February 19, 2020  
*Updated March 10, 2020*

Responses to Comments from SCAQMD, Attorney General, CDFW and Blum Collins LP Letters on  
Latitude Business Park Mitigated Negative Declaration

**Table 1: SCAB 24-Hour Average Concentration CO Trend**

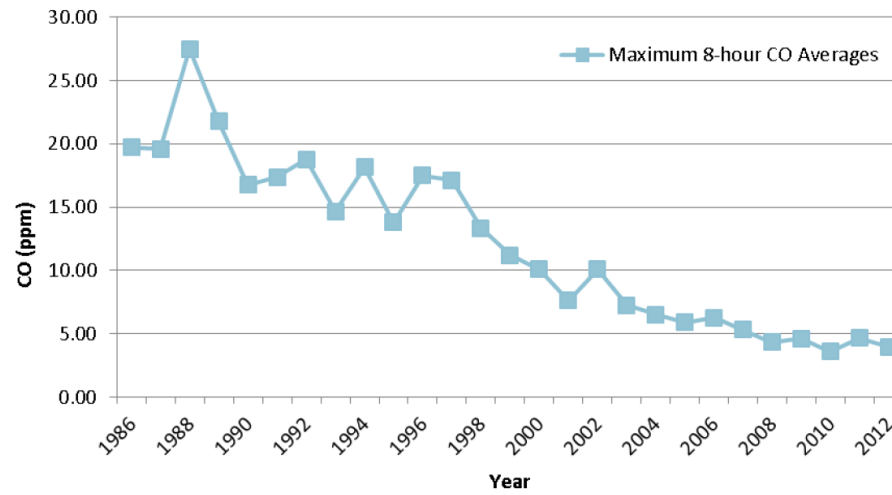
Comment	Response
<p>1. Localized Significance Thresholds (LST) Analysis for CO and PM2.5: The Lead Agency performed air dispersion modeling to analyze the Proposed Project’s localized construction air quality impacts for NOx and PM10 and compared those with the most stringent air quality standards to determine the level of significance<sup>13</sup>. However, the Lead Agency did not analyze the localized air quality impacts for CO or PM2.5 in the MND. South Coast AQMD staff recommended that the Lead Agency analyze the Proposed Project’s localized air quality impacts from construction activities for CO and PM2.5 and compare those emissions to the most stringer air quality standards, or provide reasons.</p>	<p>1. PM 10 and PM 2.5 have a threshold of 10.4 µg/m<sup>3</sup>. The project emissions for PM 10 were found to generate emissions less than 10.4 µg/m<sup>3</sup>. Given that project PM 10 emission are higher than project PM 2.5 emission, the LST impacts from PM 2.5 would also be less than 10.4 µg/m<sup>3</sup>. LSTs for CO were not calculated because ambient air quality data for CO is no longer monitored within the County of Riverside or at least the data isn’t readily available.</p> <p>CO concentrations in the SCAB have decreased markedly — a total decrease of more about 80 percent in the peak 8-hour concentration since 1986 (See Table 1 on page 7). It should be noted 2012 is the most recent year where 8-hour CO averages and related statistics are available in the SCAB. The number of exceedance days has also declined. The entire SCAB is now designated as attainment for both the state and national CO standards. Ongoing reductions from motor vehicle control programs should continue the downward trend in ambient CO concentrations.</p>
